Access Compliance Report

Public Rights-of-Way

(Pedestrian Signals)

Intersection ID: N/A	Main Street:	Cross Street: N/A	Location: N/A
ADA ID: CBE42996EA7A	Signal Type: Two Push Buttons-Non APS	Overall Compliance: No	Severity Score: BTN 1:N/A BTN 2: N/A No BTN: N/A
Codes/Mitigation Info/Possible Solution		Field Measurements/Component Compliance

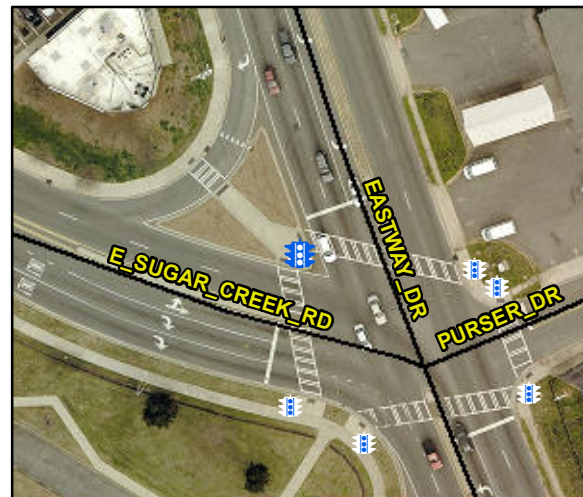
Surveyor Notes: TEXT HT 5/16

PROW/ADA: R410.6, R209.1, TMUTCD 4e.08, R404.2, R406.2, R404.7.3

Possible Solutions: Replace Signal Push Button With APS Button on New Post. Remove & Replace Sign. Provide Push Button Extension. Remove and Replace Clear Space.
